Baseline Monitoring Report

Wingfoot Riparian Buffer Mitigation Site

Re: Wingfoot Baseline Report
Neuse 03 River Basin, Contract #7607, Pitt County, DMS Project No. 100078

**Re: Wingfoot Mitigation Plan (DMS Project No. 100078)
Baseline Report - Response to Comments**

Figure 8A
 Mitigation Plan Overview

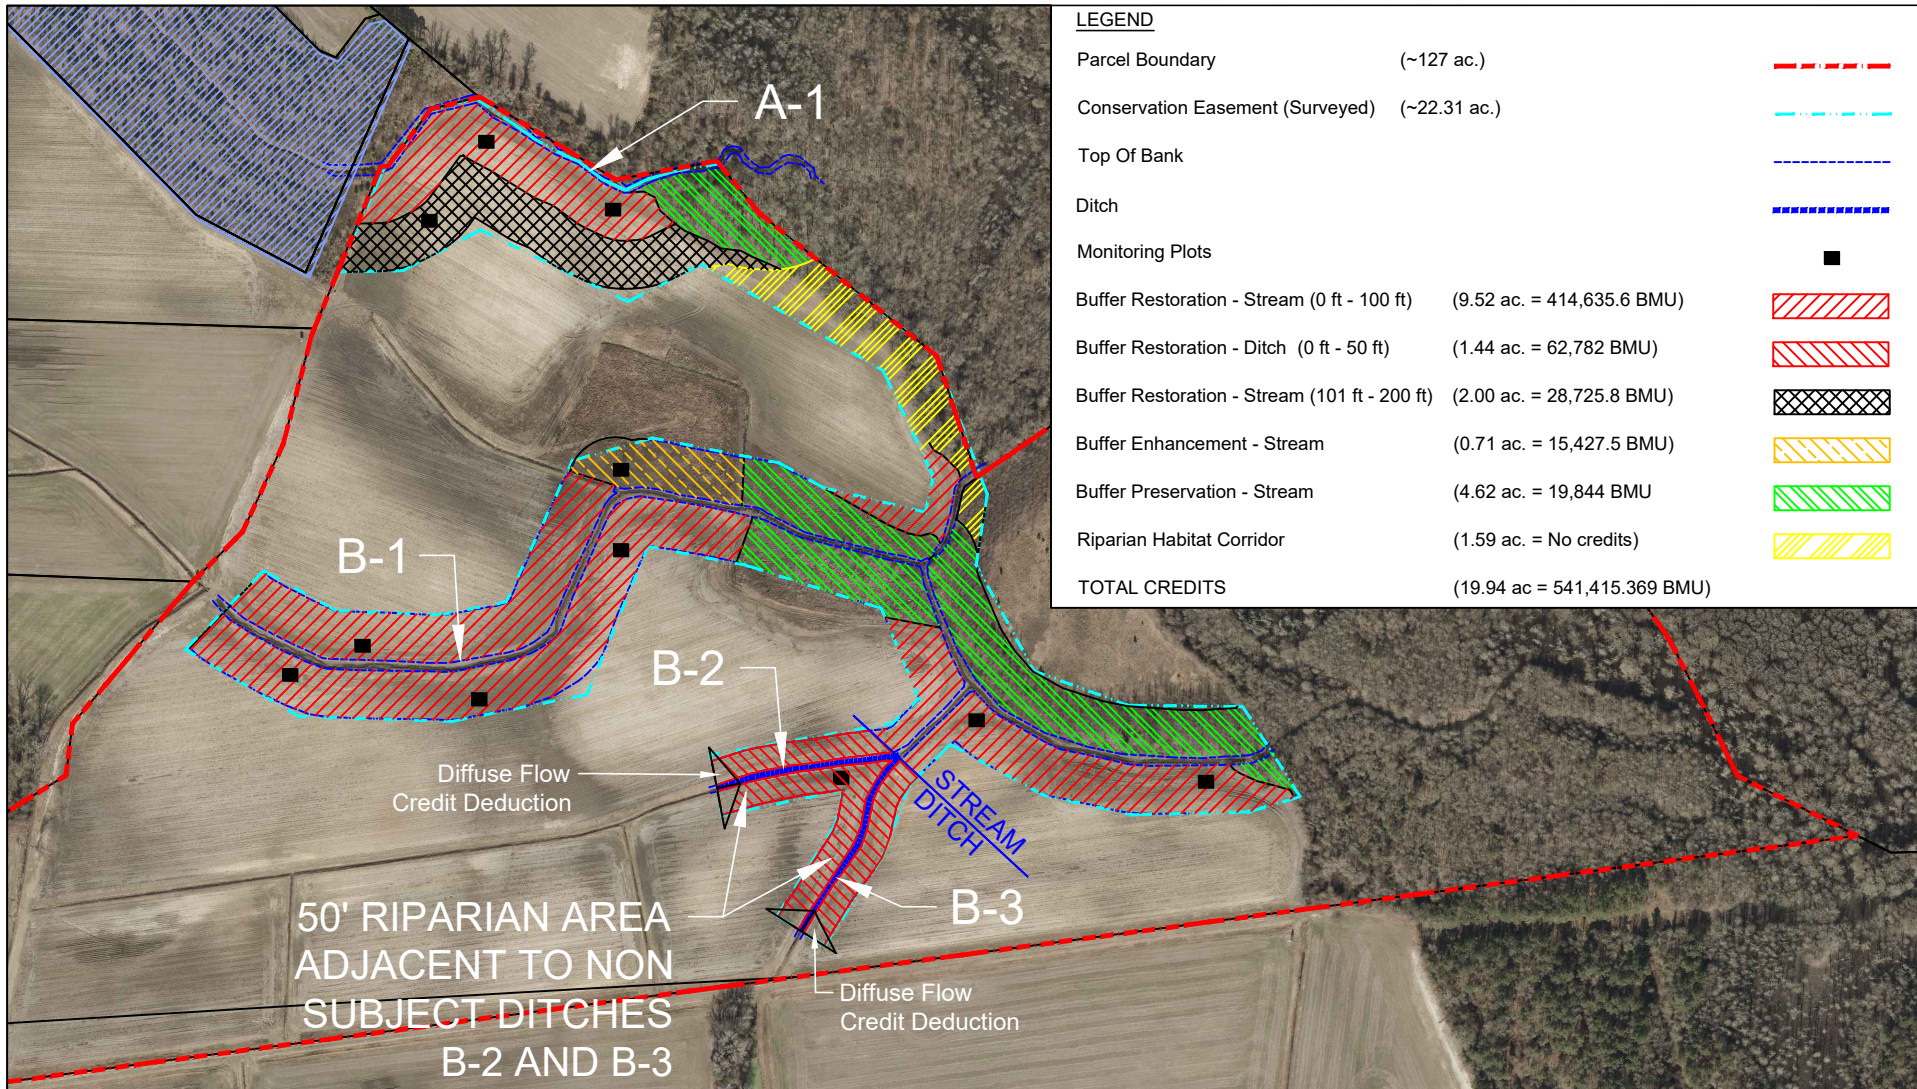
6. Figure 8A and 8 B. Revise areas and credits on map OR remove those area/credit units from map and just show on Table 2.
7. Appendix A-D. Not needed because these items are already in the Mitigation Plan, same goes for some maps if Clearwater wants to thin those (make sure to keep asset and monitoring maps).

6. Figure 8A and 8 B. Revise areas and credits on map OR remove those area/credit units from map and just show on Table 2.

Re: Figures 8A and 8B have been revised to reflect corrected credits and areas.

Figure 9
Monitoring Plan View

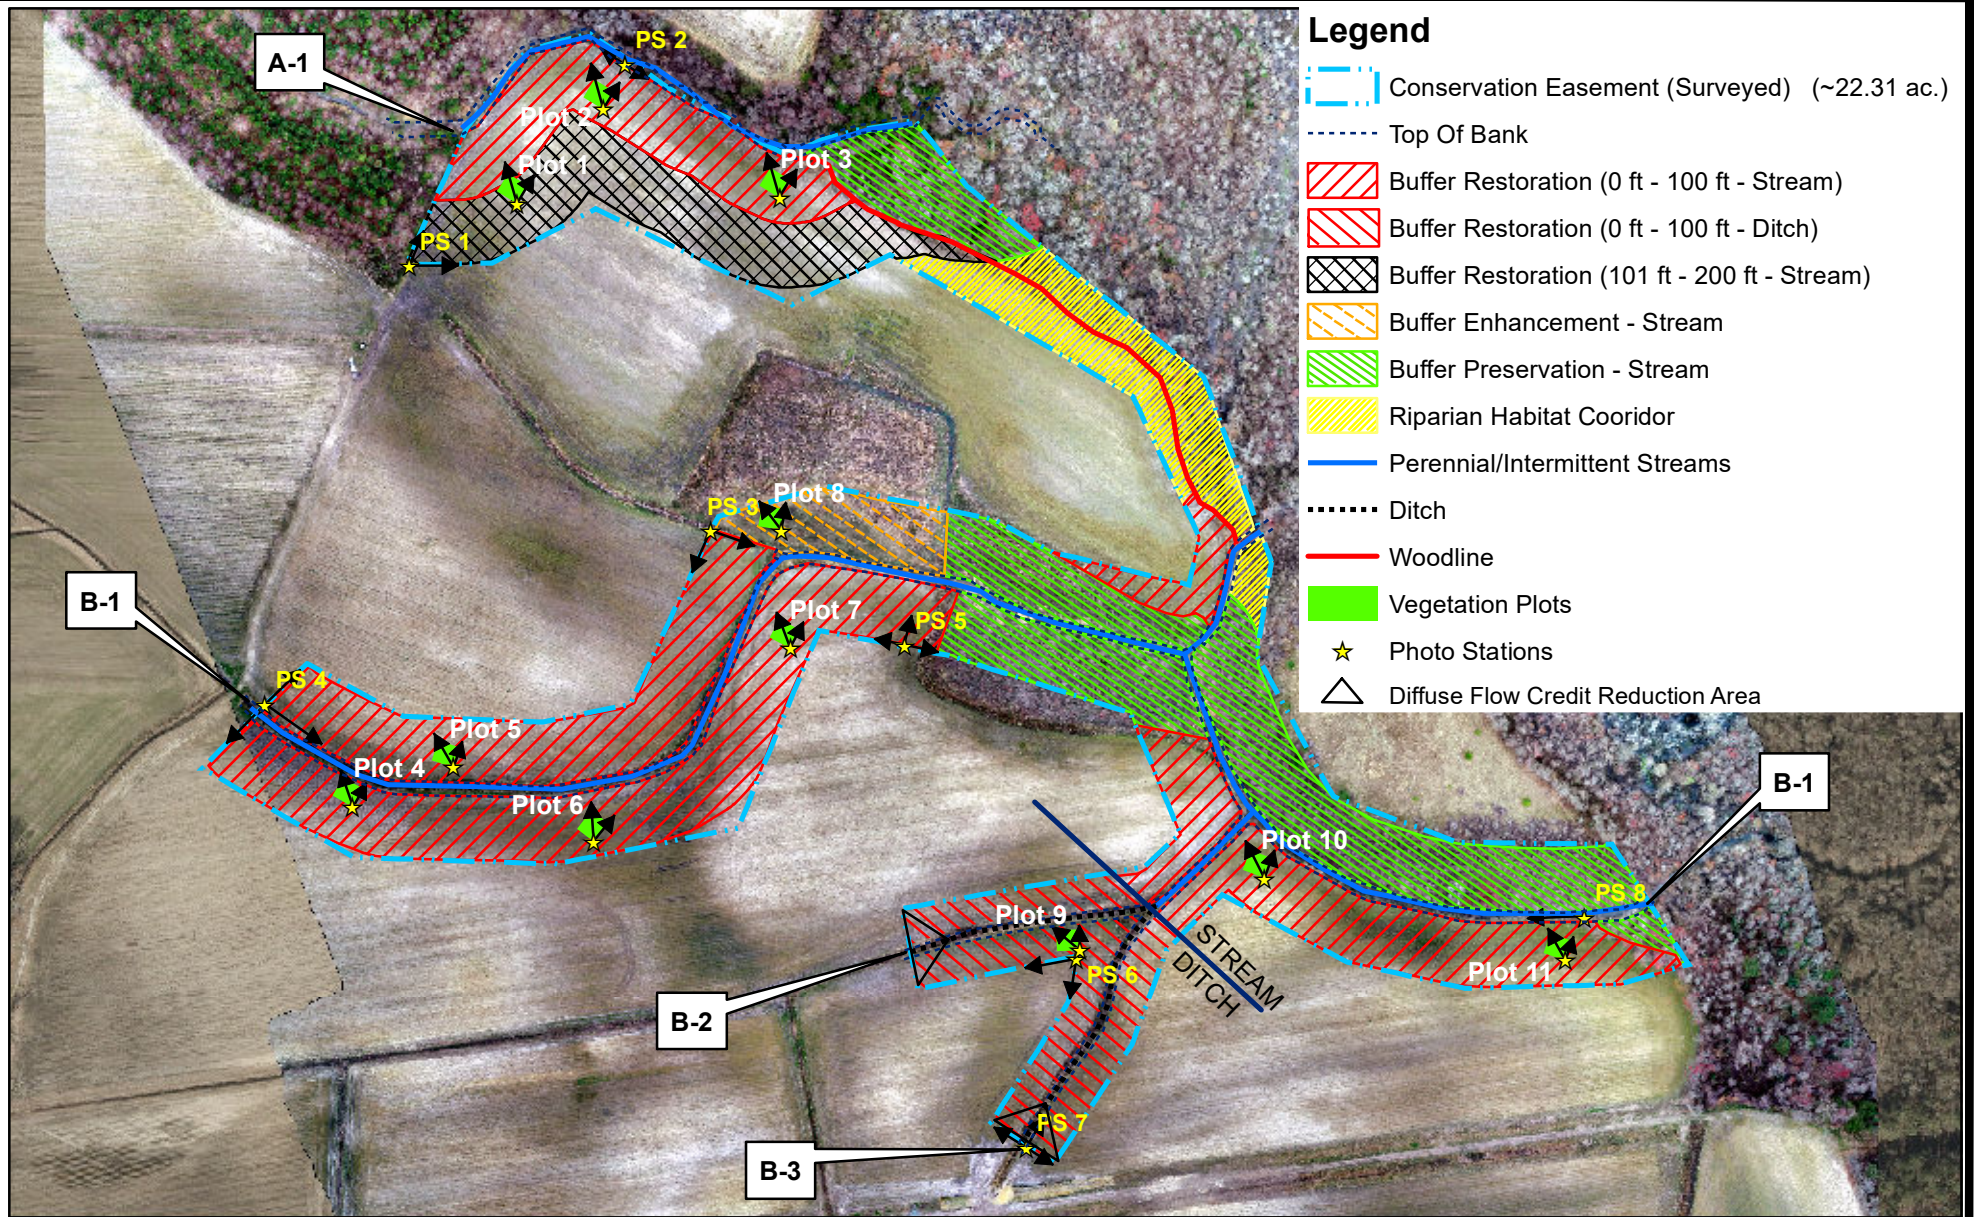
3. Figure 9, the ditch features are not broken out and are attributed incorrectly. If you want to include this map, please show ditches as different than perennial or ephemeral channels. Ensure these designations match the DWR calls. As far as I could tell, there are no ephemeral channels designated on this site.

3. Figure 9, the ditch features are not broken out and are attributed incorrectly. If you want to include this map, please show ditches as different than perennial or ephemeral channels. Ensure these designations match the DWR calls. As far as I could tell, there are no ephemeral channels designated on this site.
Re: Ditch designations within Figure 9 have been broken out, attributed correctly, and match the DWR calls.
